SUBJECT: VOGTLE ELECTRIC GENERATING PLANT ESP SITE - ISSUANCE OF
AMENDMENT RE: REQUEST FOR CHANGES TO THE CLASSIFICATION OF
BACKFILL OVER THE SLOPES OF UNITS 3 AND 4 EXCAVATIONS.

Amendment No. 3
Early Site Permit (ESP) No. ESP-004

SAFETY EVALUATION BY THE OFFICE OF NEW REACTORS
RELATED TO AMENDMENT NO. 3 TO EARLY SITE PERMIT NO. ESP-004
SOUTHERN NUCLEAR OPERATING COMPANY
VOGTLE ELECTRIC GENERATING PLANT ESP SITE
DOCKET NO. 52-011

Figure 1. Power Block Excavation Sections (Source: Reference 1)

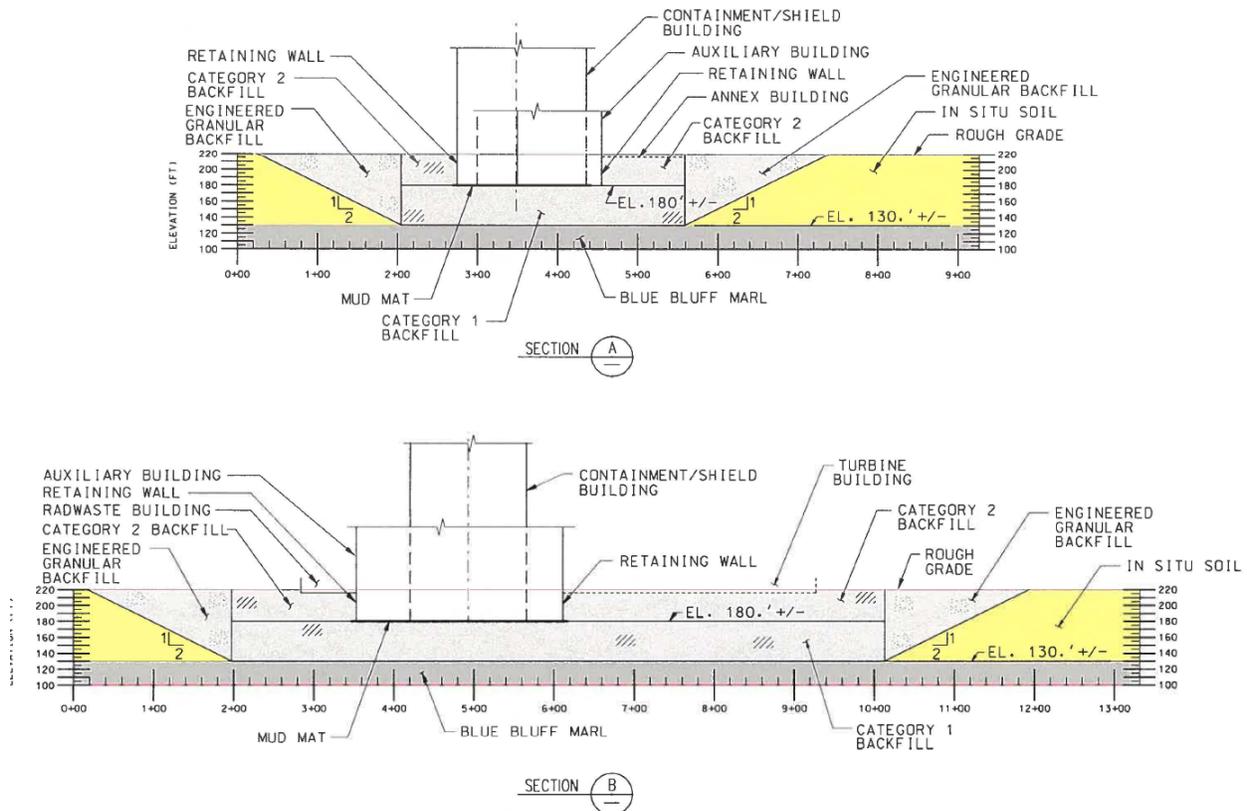
Engineered granular backfill (EGB) will be placed above the slopes, outside the specified lateral extent of the Category 1 and 2 backfill, as defined in Figure 2.5.4-16. The areas where EGB will be placed will not affect the static or seismic performance of the safety-related facilities. The EGB will be well-compacted granular backfill meeting the following requirements;

The applicant revised SSAR Figures 2.5.4-16 and 2.5.4-17 accordingly to illustrate the location and extent of the EGB. Figure 1 below replicates the revised SSAR Figure 2.5.4-16. The applicant also revised SSAR subsection 2.5.4.5.4, "Backfill Sources" to reflect the reduced quantity of Category 1 and 2 backfill needed for construction.

The applicant's proposed Power Block Excavation Sections are shown in SSAR Figures 2.5.4-16 and 17. The staff reviewed these figures and noted that a vertical boundary between the engineered granular fill and the Category 1 and 2 backfill is proposed. The staff found that the SSAR did not describe how this vertical boundary would be maintained during construction and was concerned that misalignment of this boundary could result in an as-built difference with what was assumed in the seismic analysis models. To address this issue, the staff issued RAI VGAMEND#2 - 3.7.2-2, which requested that the applicant describe how this boundary will be maintained during placement of backfill such that the Category 1 and 2 backfill zones will not be mixed with EGB.

In a June 22, 2010 letter response, the applicant stated that in terms of placement of compaction, the construction procedures will assure that the horizontal extent of the Category 1 and Category 2 backfill will be maintained beyond the extent assumed in the analysis. The Category 1 and 2 backfill will extend beyond the vertical interface to assure that any blending of the EGB will occur outside of the vertical interface assumed in the analysis. Compaction of the EGB will be controlled as a distinct effort because moisture conditioning and materials for the EGB and Category 1 and 2 backfills may be different. At this interface, the applicant plans to make overlapping passes with compaction equipment which will provide assurance that material across the interface will be compacted to the specified requirement of 95% of ASTM D1557.

The staff reviewed the applicant's proposed method for maintaining the vertical interface between the EGB and the Category 1 and 2 backfill materials. Based on the applicant's proposal to have the interface of the EGB material extend beyond that assumed in the site-specific seismic analysis, and the overlapping passes with compaction equipment, the staff finds the applicant's method acceptable.
